Service Bulletin

Number: A6-87-17

SL-P1200
Compact Disc Player

Symptom: 1) No operation at all.
2) Unit reads the T.O.C. but fails to enter the play mode.

FIGURE 1 - PCB LAYOUT (TRANSISTORS LOCATION)

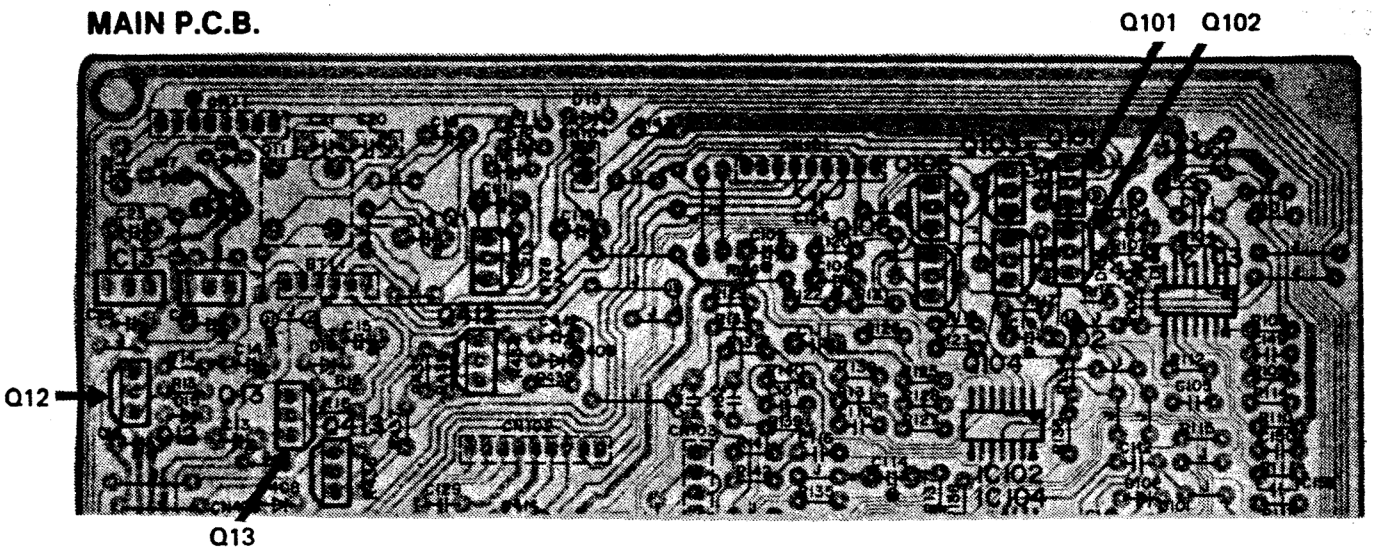
Each of the above conditions cause Q12, Q13, Q101, and Q102 to overheat and become damaged. The excessive heat causes the transistor's solder joints to dry and therefore cause poor connection, or solder bridges.

Remedy: 1) Order kit number SZZP1093C. Refer to the kit contents below.
2) Replace the transistors as indicated in Figure 1.
3) Mount the heat sink to IC501 as shown and indicated in Figure 2.

DESCRIPTION	REF. NO	ORIGINAL PART NO.	NEW PART NO.	KIT PART NO.
TRANSISTOR	Q12	2SC1846 OR 2SD973	2SD1266	SZZP1093C
TRANSISTOR	Q13	2SA885 OR 2SB793	2SB941	
TRANSISTOR	Q101	2SD1055	2SD1266	
TRANSISTOR	Q102	2SB822	2SB941	
HEAT SINK	----	----------	SMWD3E

FIGURE 2 - MOUNTING THE HEAT SINK SMWD3E

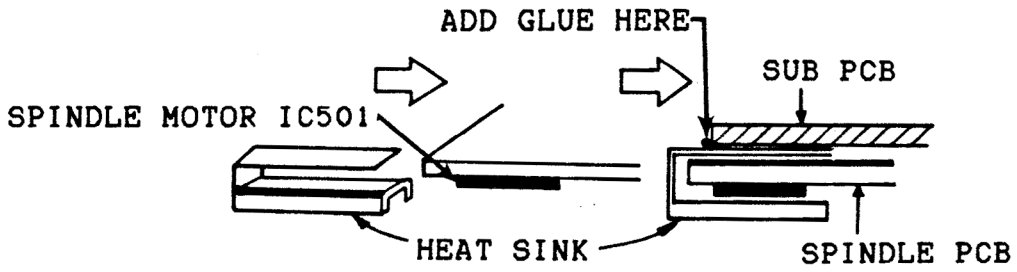
Cause: The spindle drive IC (AN8290S) overheats and locks-up when:

A) Loosen the spindle PCB and sub PCB mounting screws.
B) Insert the heat sink's thin leaf between the spindle, PCB and sub PCB.
C) Mount the PCBs.
D) Secure the thin leaf of the heat sink to the sub PCB using "3M" type glue.
